Index 102-603

Two-Lane, Two-Way, Work Within The Travel Way

COMMENTARY

LAST REVISION 11/01/21	REVISION	DESCRIPTION:	 FY 2022-23 STANDARD PLANS	TWO-LANE, TWO-WAY WORK WITHIN THE TRAVEL WAY	INDEX 102-603	SHEET 1 of 2
---------------------------	----------	--------------	----------------------------------	--	------------------	-----------------

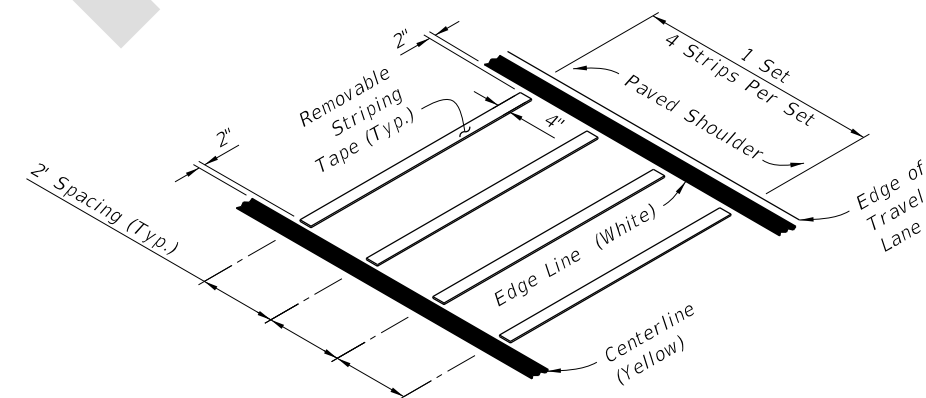
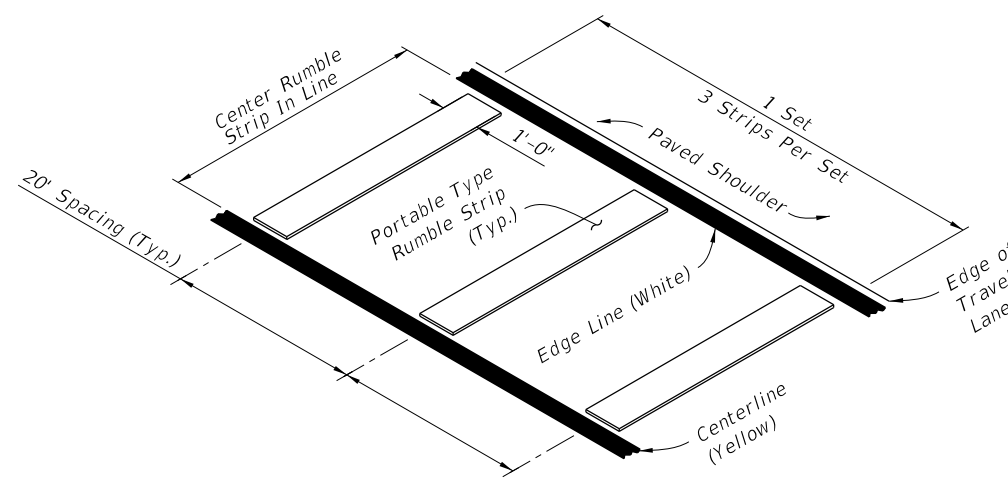
Sheet 1: Changed Note 6 - "work zone" to "work operations"; Changed Note 8B - "work zone" to "work operations"; Changed Note 9 - "ridable shoulder" to "4' or greater paved Shoulder".

COMMENT: Is the 4-ft paved shoulder provision intended to apply to all roadway types (i.e., limited access facilities vs. Arterials/Collectors)?

RESPONSE: No, only 4' or wider paved shoulder on non-limited access facilities are considered "Bicycle Facilities".

Change Made: Instead of revising the Note further, it has been decided to remove the redundant note from all relevant 102 Series Indexes. The FDM provides guidance on bicycle accommodations and Specification 102-3.4 will be updated to clarify the definition of a "Bicycle Facility" (i.e., existing marked Bicycle Lane or a 4' or greater paved shoulder on non-limited access roadways). **Note Deleted.**
